Plan Commission

Agenda

Monday, September 28, 2020

PROJECT MANAGER: M. NYSTED
DESIGNER:
DRAWN BY:
EXPEDITOR:
SUPERVISOR:
PRELIMINARY NO: P20096
CONTRACT NO:
DATE:
SHEET: **C4.1**

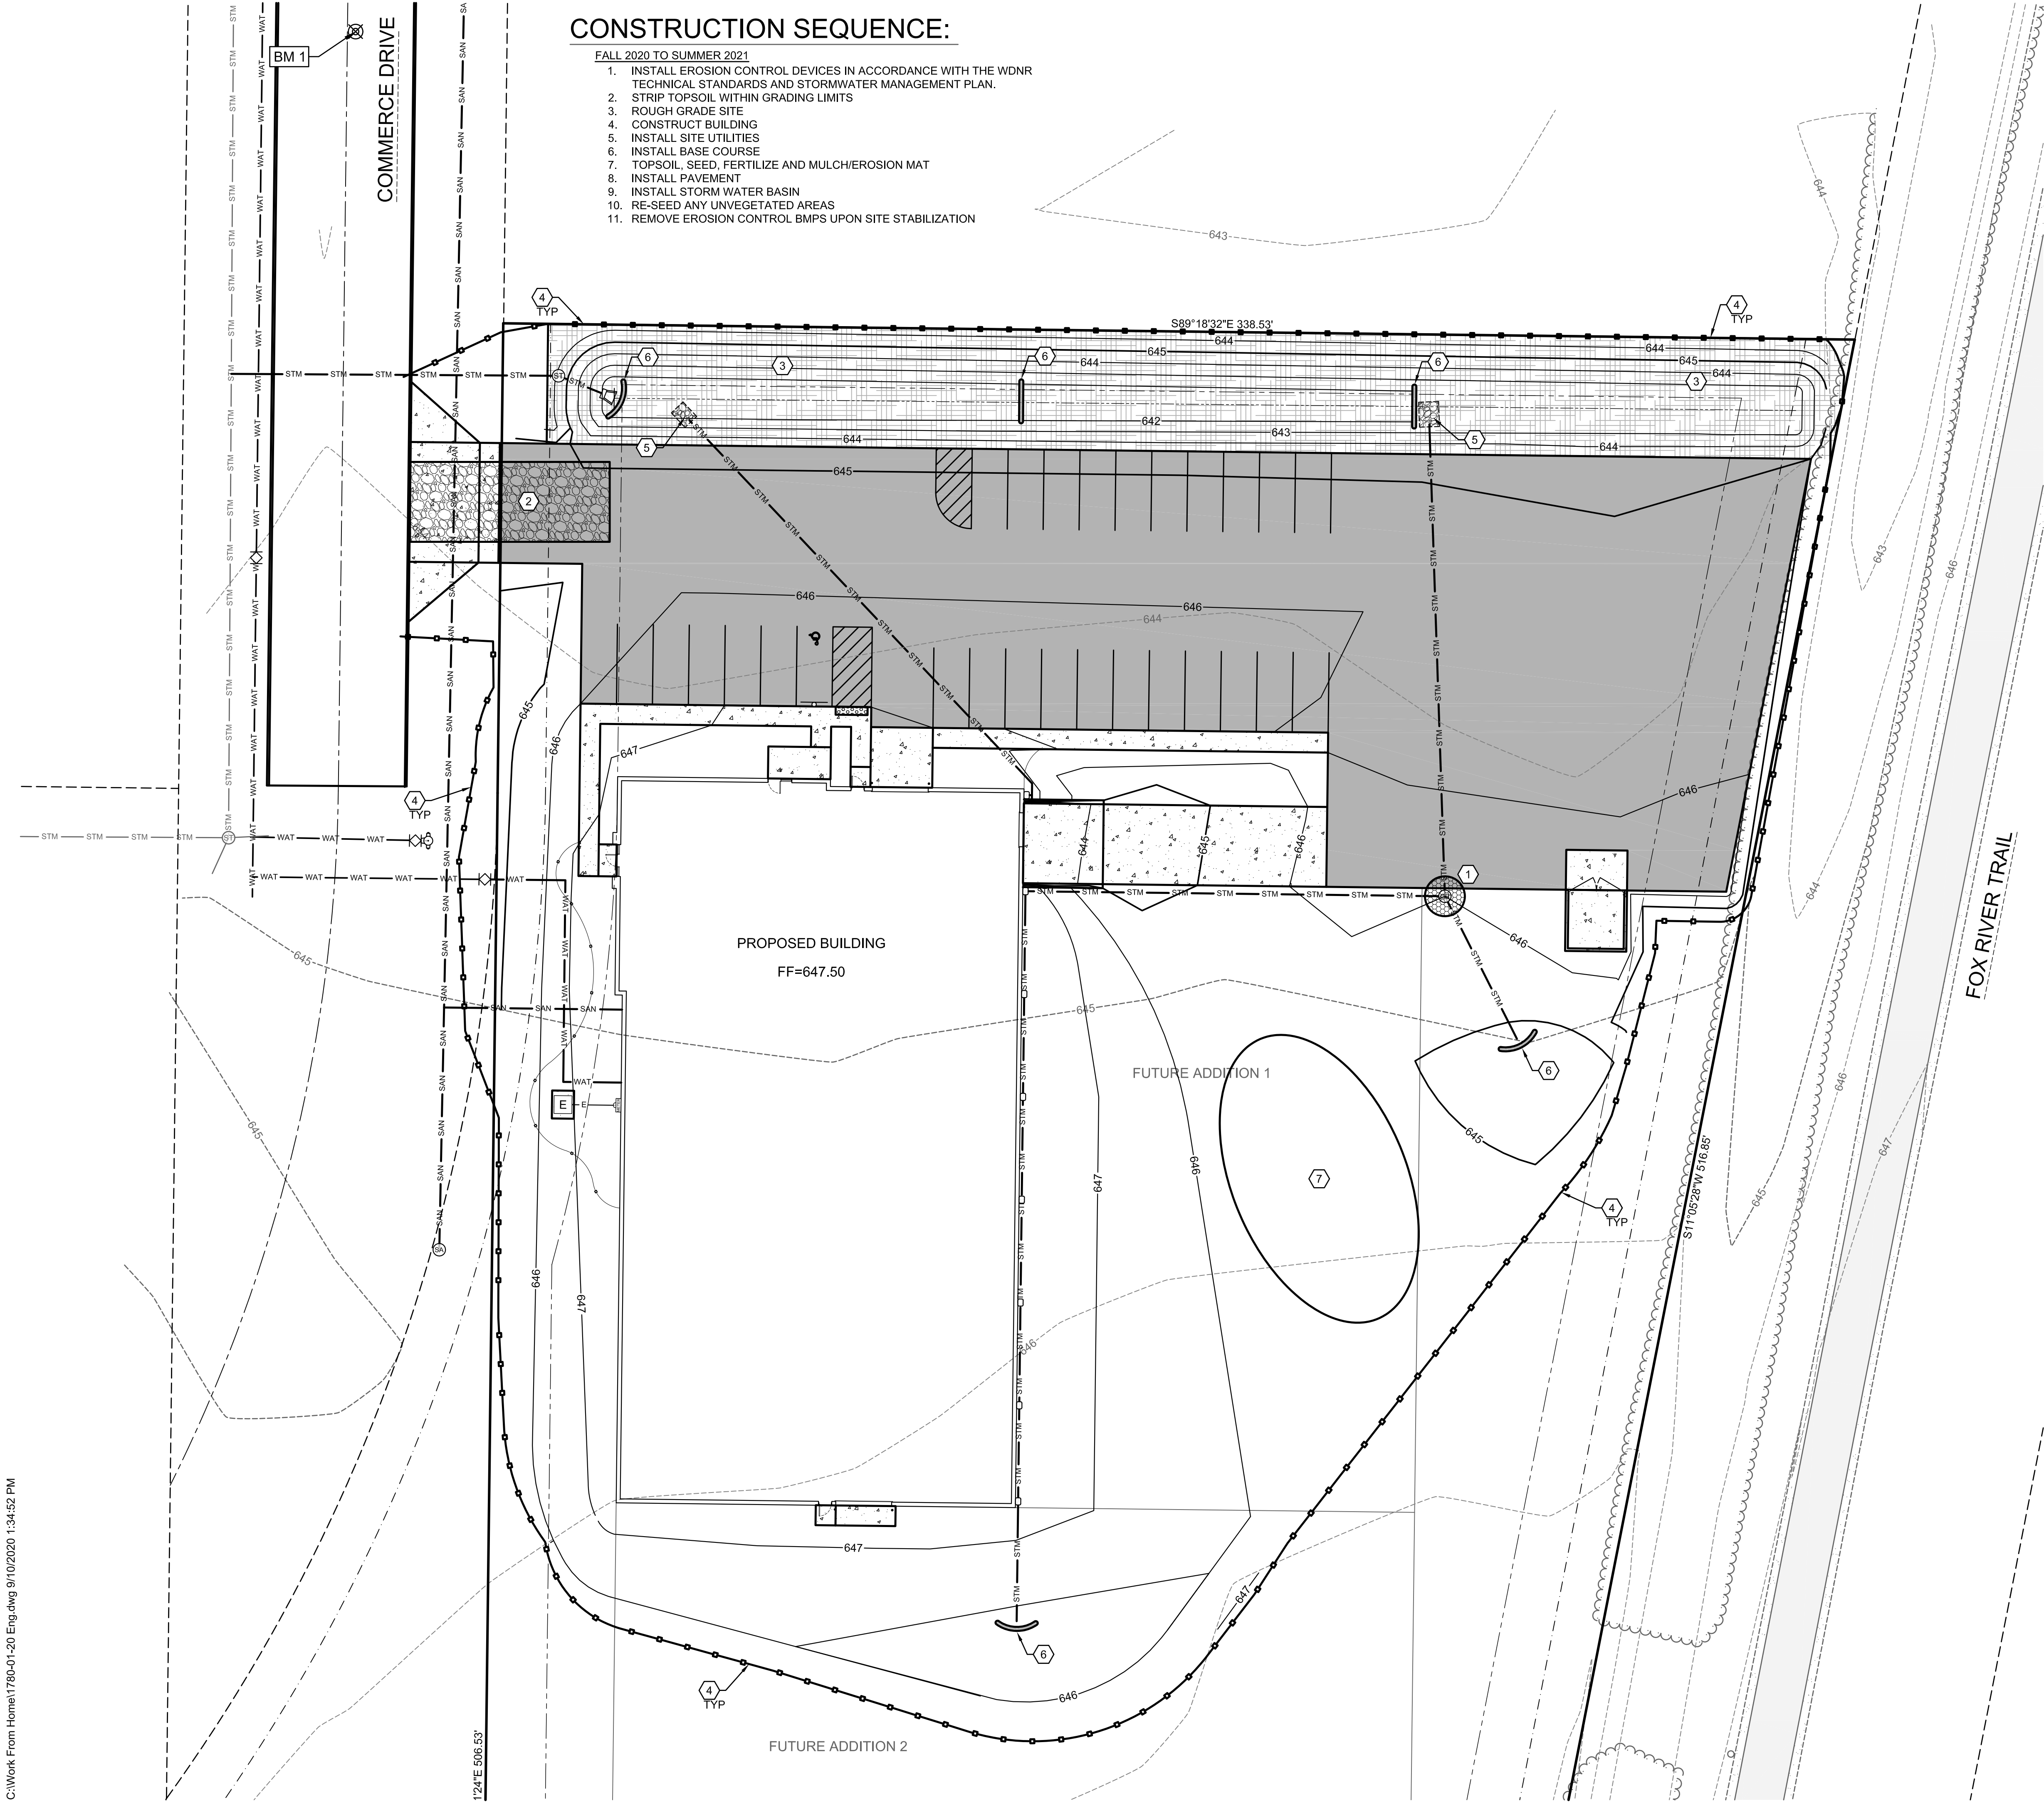
6. On Sheet C4.1:
 - a. This is the only grading plan. The sheet title does not need to be labeled "north". Naming the sheet north implies there are additional sheets.

SHEET:
C5.1

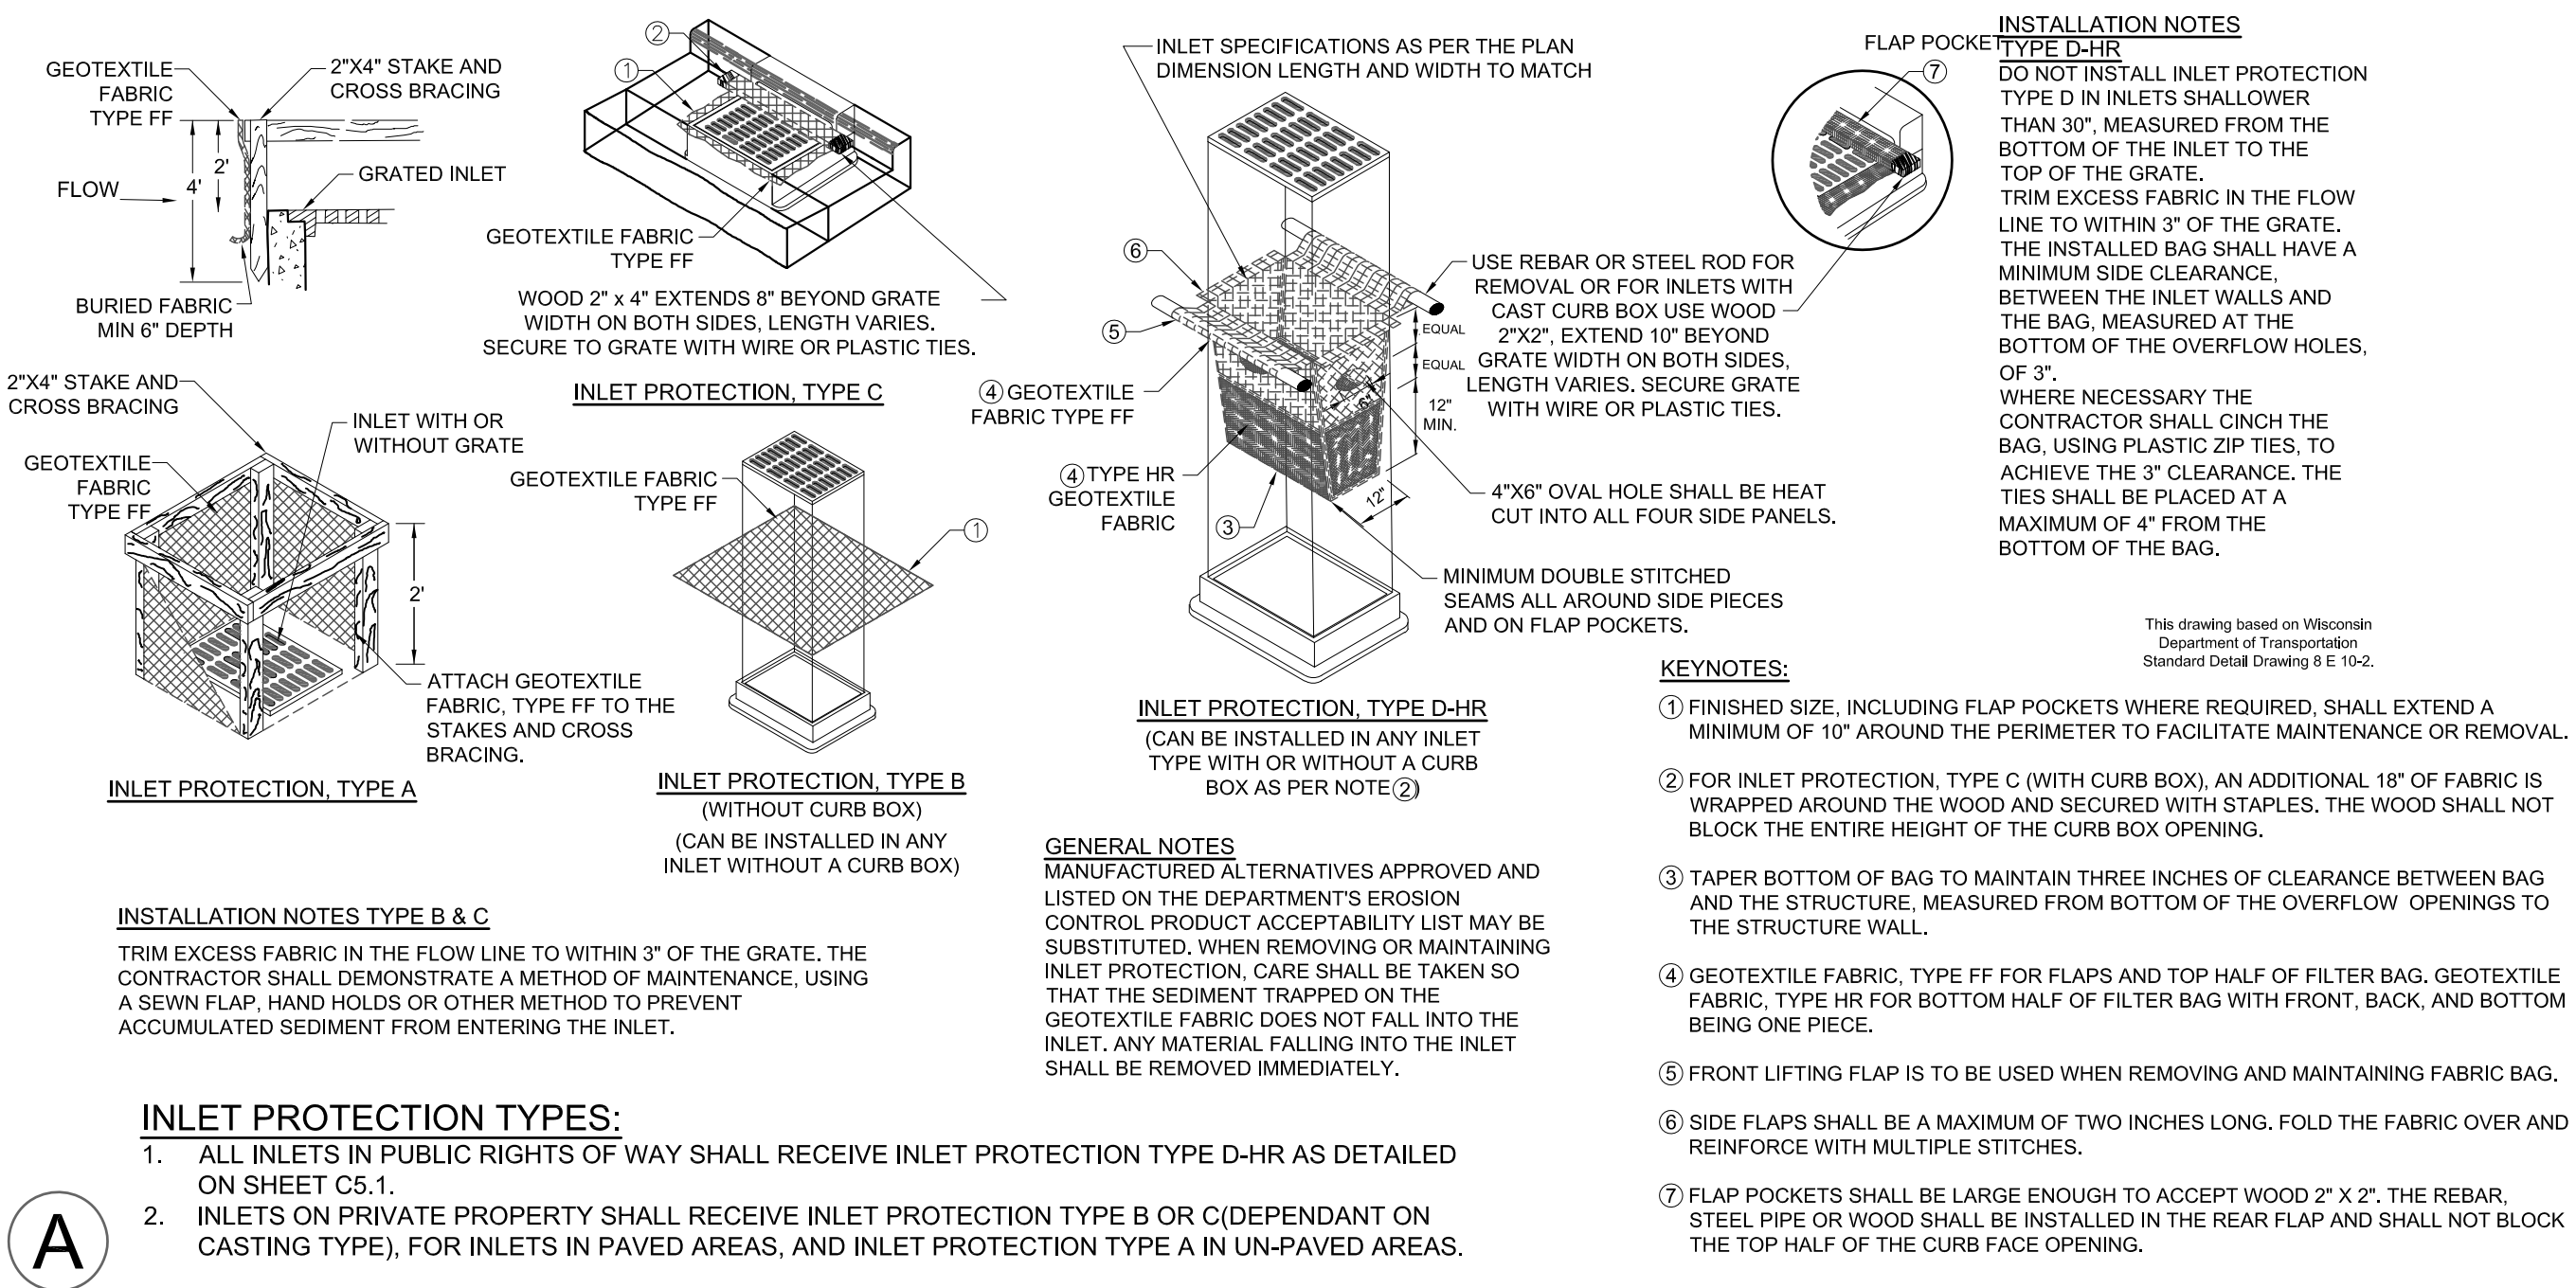
7. On Sheet C5.1:
 - a. This is the only erosion control plan. The sheet title does not need to be labeled "north". Naming the sheet north implies there are additional sheets.
 - b. Provide WisDNR soil loss and sediment discharge calculations with a corresponding map.
8. On Sheet C6.0:
 - a. Detail B - Concrete Pavement/Slab Section. The City recommends utilizing 8-inch concrete, especially for the driveway apron entering the parcel.
9. General:
 - a. Provide an exterior lighting plan.
 - b. Any plan revisions shall be clearly bubbled and a summary shall be provided for ease of review.
